NHTSA Recall Number: 16V-542 School Bus
NHTSA Recall Number: 16V-543 Non-School Bus

Subject: RECALL R16YT, Propane Fuel Line Routing

Propane Fuel Line Routing

**Models Affected: Certain 2015 through 2017 Model Year Vision Buses
Equipped with Propane Engines**

INSPECT FUEL LINE ROUTING BELOW FRPCM

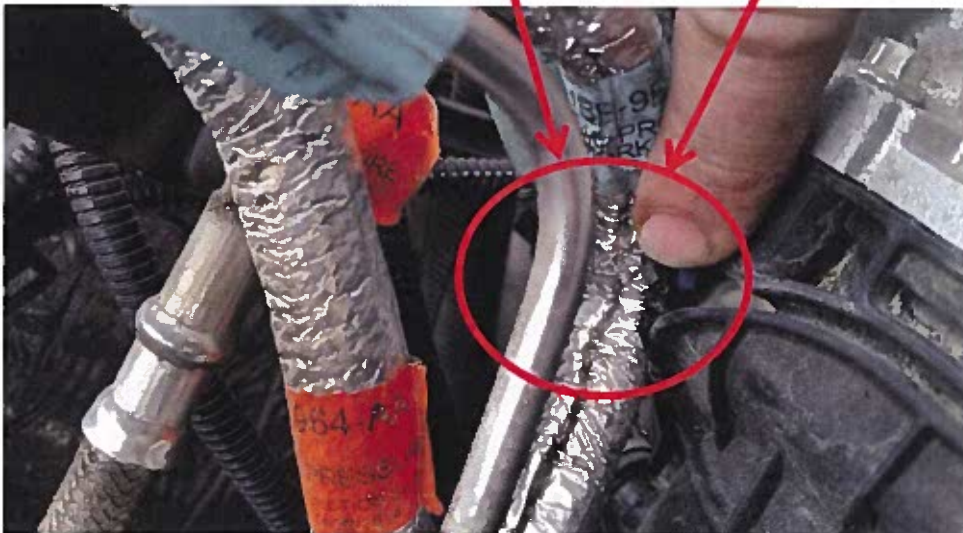
Fuel line damaged from contact with air intake tube

4. Inspect for clearance between the fuel lines and the air intake tube.
5. If the fuel lines are contacting the air intake tube, inspect for damage to the fuel lines and follow reroute instructions.

6. See Page 6 for help in identifying a good or damaged fuel line. If any fuel lines are damaged, follow replacement instructions.

Photo 1
(Viewed from front of engine)

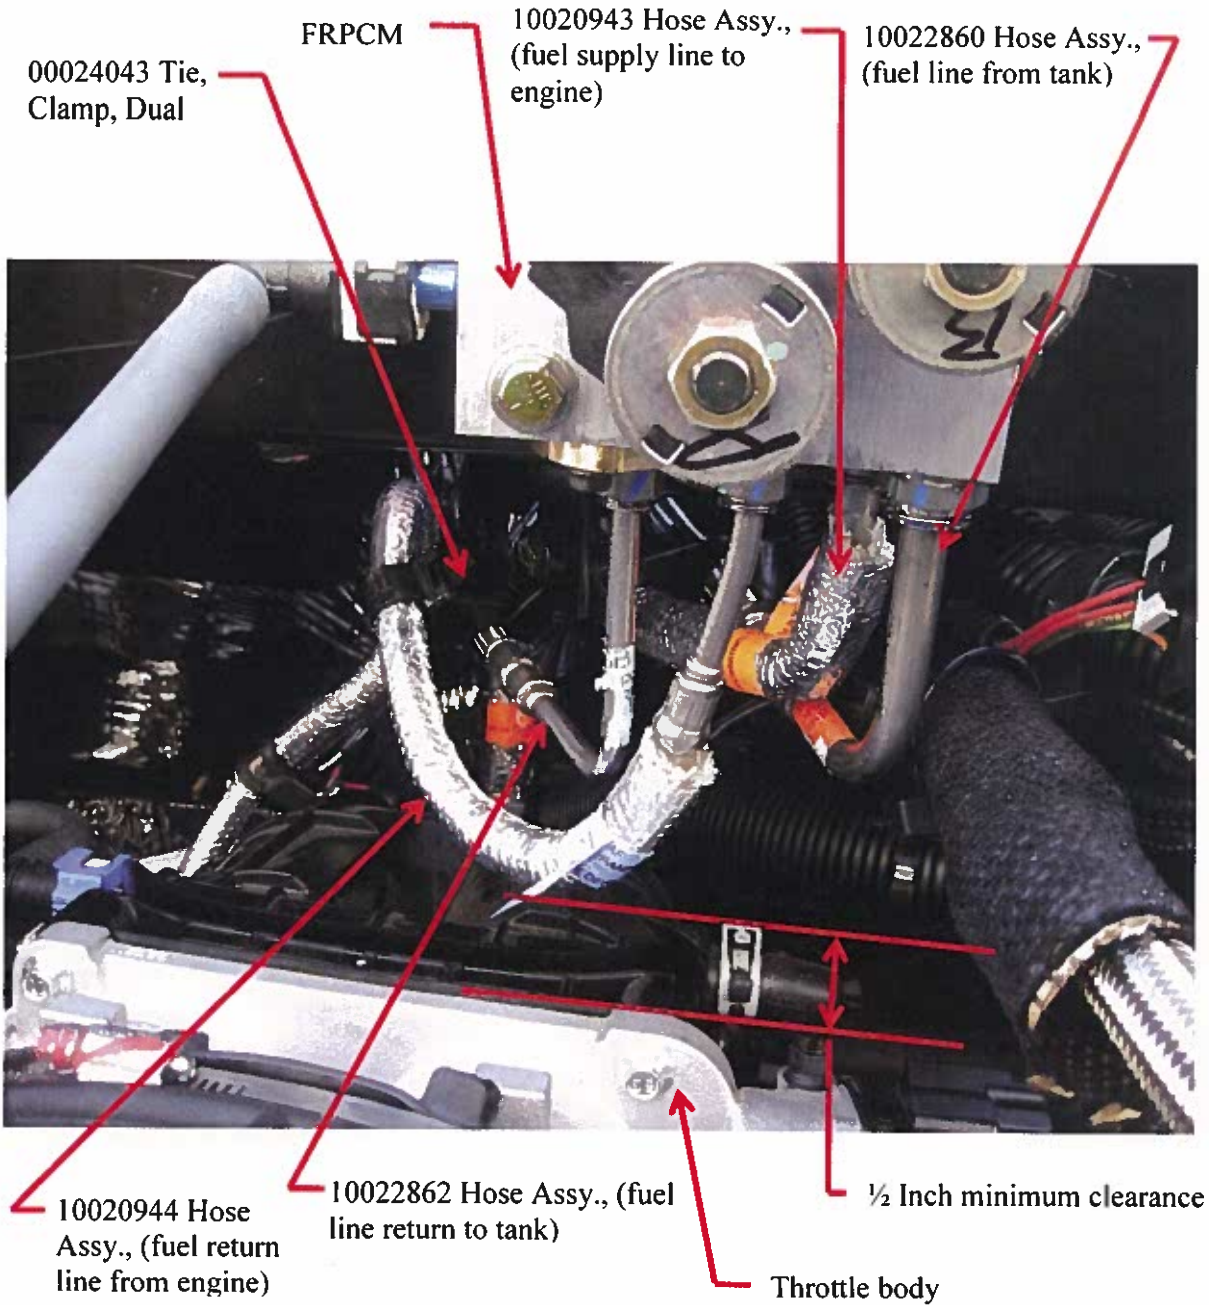
5. Using Photo's 1, 2, 3, and 4 in the **Proper Routing and Clamping Section** as your guide, reroute the four fuel lines to be parallel with each other. Install two or three dual clamp ties Part Number 00024043 to maintain separation.

- b. **Be sure to follow ALL of the Warnings and Cautions in the propane section of Blue Bird Service Manual.**
6. Maintain 1/2 inch minimum clearance between the throttle body/air intake tube and the bottom of the fuel lines (See Photo 1).
